PROCEDURE - LPG SYSTEM SECONDARY REGULATOR REPLACEMENT

MAY 25 1990	
PART NO. 3940897 QTY 1 UNIT PRICE \$12.50 TOTAL \$12.50	PART NO. 3931763 QTY 1 UNIT PRICE \$12.50 TOTAL \$12.50	PART NO. 2202102 QTY 1 UNIT PRICE \$12.50 TOTAL \$12.50	PART NO. 2026664 QTY 1 UNIT PRICE \$12.50 TOTAL \$12.50
DIMGRAM, LP6 VENT, REFRIGERATOR COMPARTMENT, FIELD FIX			
DR. 8/18/89 BY RMY APP. 9/22/89 BY NP	SIZE C	3939196

DETAIL A

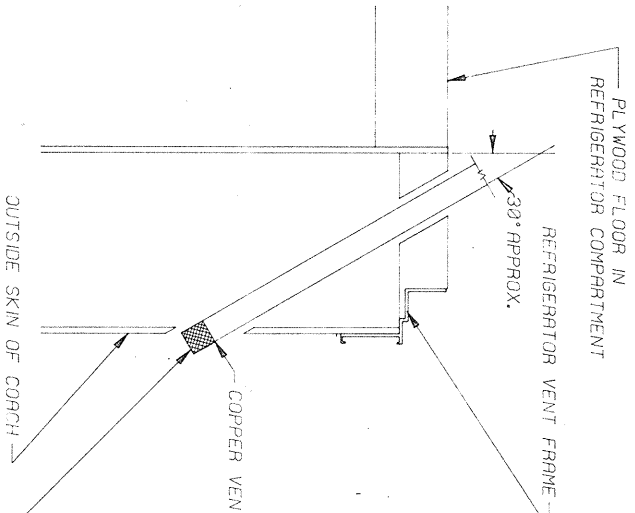
1. SHUT OFF LPG AT TANK.
 2. LOOSEN 3/8 FLARE NUT AT BOTTOM OF REGULATOR.
 3. REMOVE REGULATOR (UNSCREW AT TOP FITTING).
 4. REMOVE FITTING FROM BOTTOM OF REGULATOR AND INSTALL IN FISHER REGULATOR, P/N 3931763.

5. CUT WIRES TO MARSHALL BRASS SOLENOID (CLOSE TO SOLENOID).
 6. REMOVE HAND SHUT OFF VALVE, MARSHALL BRASS, AND FITTINGS UP TO 1/2" CROSS. HOLD CROSS WITH PIPE WRENCH SO TUBING WON'T BE DEFORMED.

7. DRILL 3/8" TO 13/32" DIA. HOLE THROUGH BOTTOM REFRIGERATOR COMPARTMENT DOOR FRAME WOOD MEMBER (2 1/2" TO 3" TO RIGHT SIDE OF 3/8" LINE) AT A 30° ANGLE WITH THE VERTICAL SO THAT IT WILL EXIT THE OUTSIDE SKIN APPROXIMATELY 2" BELOW VENT DOOR FRAME (SEE DETAIL A).

8. INSTALL NEW SOLENOID VALVE, (FPC) P/N 3940897, WITH FITTINGS, P/N 2022183 NIPPLE, 2027159 BUSHING AND 3938586 ELBOW INTO 1/2" CROSS. INSTALL ELBOW, P/N 2205110, IN VENT (TOP) OF NEW REGULATOR SO IT EXITS TO THE RIGHT.

9. INSTALL 3/8" X 1/2" FL CONNECTOR, P/N 2026664, IN TOP OF REGULATOR.
 10. INSTALL REGULATOR AND ATTACH 3/8 FLARE NUT AT BOTTOM.
 11. INSERT 1/4 TUBING (P/N 2202102) (SCREEN END) THROUGH HOLE DRILLED IN STEP 7 AND CONNECT TO 1/4" ELBOW ON REGULATOR. SCREEN END SHOULD PROTRUDE THROUGH THE BODY APPROXIMATELY 7/8". SEAL AROUND TUBE WHERE IT GOES THROUGH WOOD MEMBER.

13. CONNECT WIRES CUT OFF IN STEP 5 TO NEW SOLENOID VALVE.
 14. INSTALL CLAM SHELL COVER, P/N 3938891, OVER EXPOSED VENT TUBE SCREEN SO BOTTOM OF COVER IS FLUSH WITH BOTTOM OF SCREEN. USE A #32 DRILL TO PREPARE HOLES FOR #6 SCREWS, P/N 2186419.

15. BEND 1/2" COPPER TUBING TO MAKE CONNECTION BETWEEN TOP OF REGULATOR FITTING AND SOLENOID VALVE ELBOW WITH FLARE NUTS, P/N 3744000.
 16. INSTALL 3929031 GAS DETECTION UNIT INSIDE COACH IN PLACE OF 3752936 (MARSHALL BRASS/PMMI).

17. TURN ON LPG AT TANK.
 18. LEAK CHECK ALL FITTINGS.
 19. CHECK FLOW BY LIGHTING RANGE BURNER.
- **NOTE: ON SOME 1983 MODEL COACHES THERE WAS NO SOLENOID SHUT OFF OR LEAK DETECTOR AT REFRIGERATOR ON INSIDE OF COACH. ON THESE UNITS THE SOLENOID VALVE AND FITTINGS WILL NOT BE INSTALLED: A P/N 2260222 CONNECTOR WILL BE INSTALLED IN THE 1/2" CROSS AND 1/2 TUBING BENT SO IT WILL DIRECTLY CONNECT TO THIS FITTING.

- REMOVE SCREEN FROM REGULATOR (3931763), EPOXY TO 1/4 TUBING (2202102).
